UNITED STATES PATENT AND TRADEMARK OFFICE

APPLICATION NO.	FILING DATE	FIRST NAMED INVENTOR	ATTORNEY DOCKET NO.	CONFIRMATION NO.
09/674.039	10/25/2000	Yasuo Himuro	Q59956	9058

Office Action Summary

Europe '310

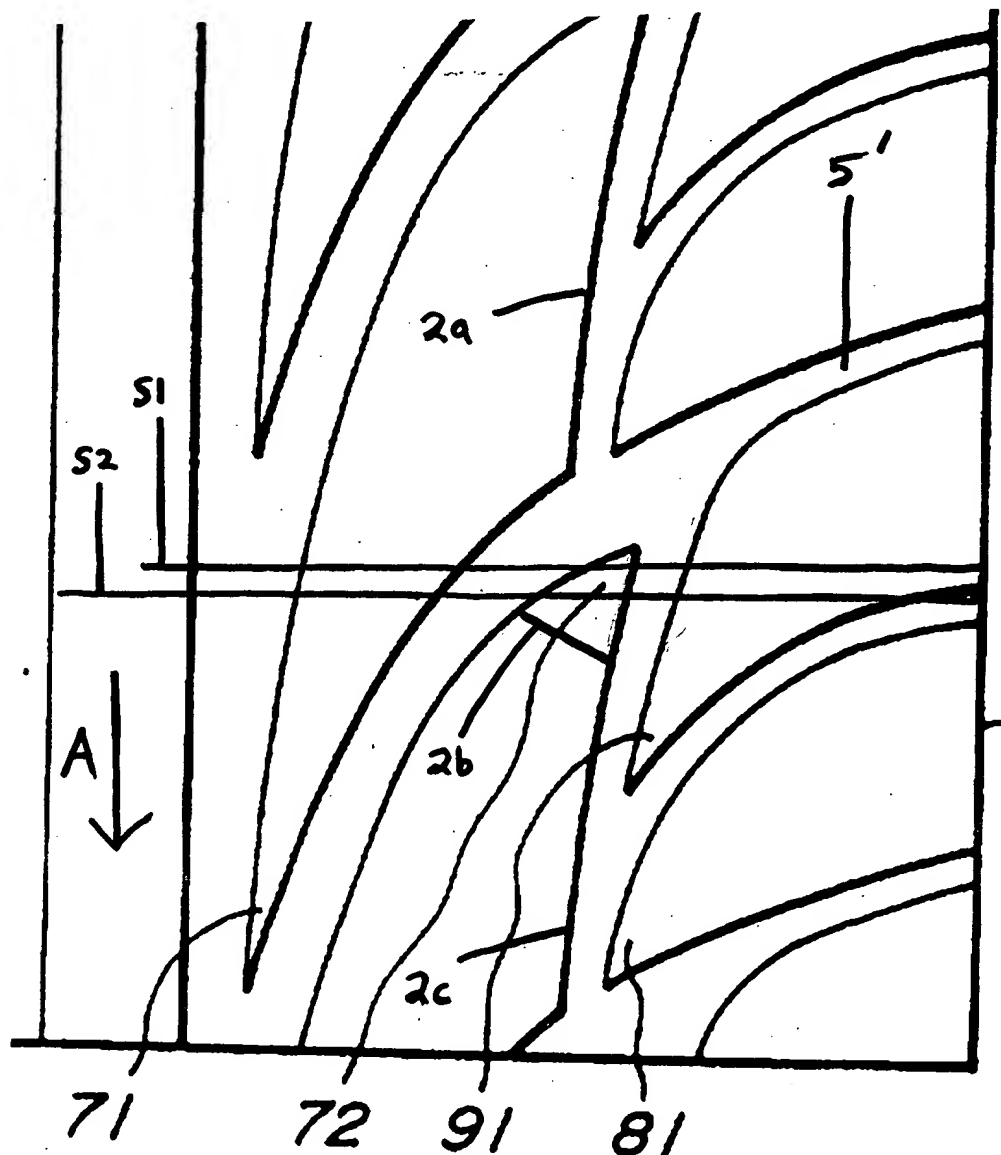
The claimed tire is anticipated by Europe '310. The claimed pseudo land portion reads on the acute angle corner portion 72 of the block, which is beveled over a distance of 10-30 mm from a tapered end thereof in a longitudinal direction so as to gradually shallow from the tapered end toward a width widened portion. Europe '310 teaches that the beveling obtains *smooth conduction of branching and joining of water flow*. In order to facilitate understanding of the application of Europe '310 against the claims, the following copy of an enlargement of a portion of figure 1 of Europe '310 is provided:

The markings for S1, S2, 5', 2a, 2b and 2c and A were added by the examiner.

Markings S1, S2 and 2b are not to scale.

As to the pseudo-land portion comprising "a slant face on a ground contact side so that the slant face does not contact a ground surface" (claims 3, 31), Europe '310 satisfies this subject matter since the upper surface of the beveled corner 72 is below the ground contacting surface of the tread.

As to "a pseudo-land portion formed in the circumferential groove", the beveled portion 72 is located "in a circumferential groove" as indicated by figure 1 wherein the outer upper edge of "the circumferential groove" is defined by one outer upper block edge (2a), the edge (2b) at which the beveled portion joins the ground contacting surface of a block and the outer upper edge (2c) of a next block. The phrase "circumferential groove" is sufficiently broad so as to read on the above non-linear outer edge (2a, 2b, 2c); it being noted that edge (2b) directly corresponds to the edge at maximum height 35 shown in figure 2a of applicant's disclosure.

As to "an end part at a larger side of the cross sectional area of the pseudo-land portion", the following comments are made: The cross sectional area at line (S2) of the beveled corner 72 near the ground contacting surface is larger than the cross sectional area at line (S1) near the apex of the beveled corner 72. The claimed end part reads on the portion extending between edge 2b and cross sectional area at line (S2). This end part is "close" to the opening of the slant groove since the beveled corner faces the slant groove 5' and is closer, for example, to slant groove 5' than the center circumferential rib; it being emphasized that "close" is a relative term.

As claims 2 and 32, the cross sectional area of the beveled corner increases in a given circumferential direction (circumferential direction A).

As to claims 4, 5 and 31, the first groove wall reads on the outer groove wall having edges defined by the outer upper block edges and the upper edge of the beveled corner (edges 2a, 2b, 2c).

As to claims 7 and 8, the height of beveled corner 72 decreases toward slant groove 5'.

Japan '024

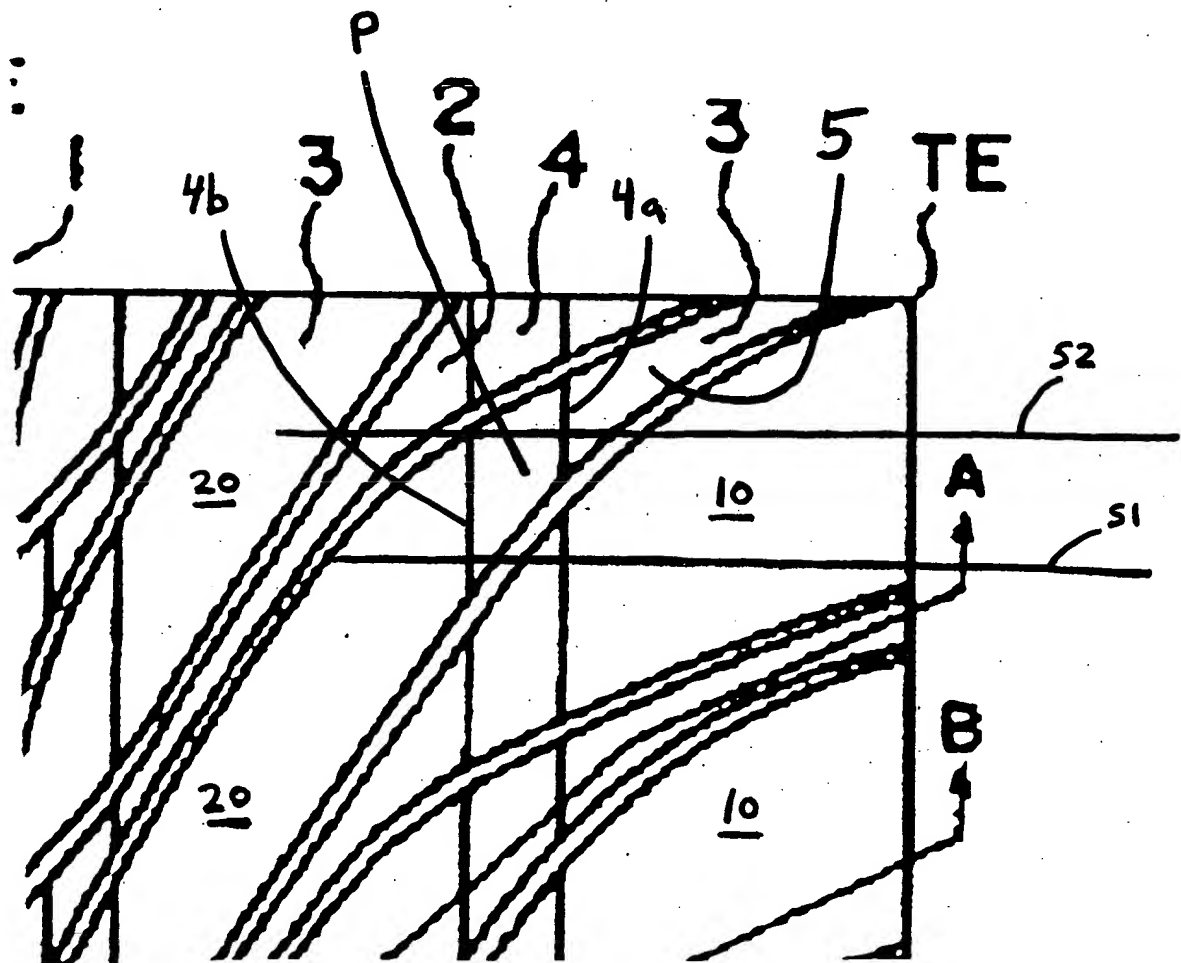
which have decreasing height toward a slant groove. The claimed circumferential groove reads on the circumferential void defined between the inner row of land portions and the outer row of land portions. See figures 1-3. The decreasing height of the projections of the rib towards the slant groove 4 inherently promotes water flow as claimed. An enlarged copy of a portion of figure 1 of Japan '024 is provided below:

The markings P, 4a, 4b, 5, 10, 20, S1 and S2 were added by the examiner. 4a and 4b are the upper edges of the "circumferential groove" 4. P is the pseudo land portion. 5

is the slant groove. 10 are the land portions of the outer row. 20 are the land portions of the inner row. S1 and S2 are lines indicating different cross sectional area locations.

As to the "pseudo-land portion comprising "a slant face on a ground contact side so that the slant face does not contact a ground surface" (claims 1, 31), Japan '024 satisfies this subject matter since the upper surface of the pseudo land portion P (inclined end portion of inner land portion 20) is below the tread surface.

As to "a pseudo-land portion formed in the circumferential groove", the pseudo land portion P (end portion of inner land portion 20) is in the circumferential groove 4 since it is located within the boundaries of the upper edges 4a, 4b of the circumferential groove.

As to "an end part at a larger side of the cross sectional area of the pseudo-land portion", the following comments are made. The cross sectional area at line (S2) of the pseudo land portion P (end portion of inner land portion 20) is larger than the cross sectional area at line S1. The claimed end part reads on a portion defined between the edge of the pseudo land portion and the line at S2. This end part is "close" to the

opening of the slant groove since it faces the slant groove 5 and is closer, for example, to slant groove 5 than the center circumferential rib; it being emphasized that "close" is a relative term.
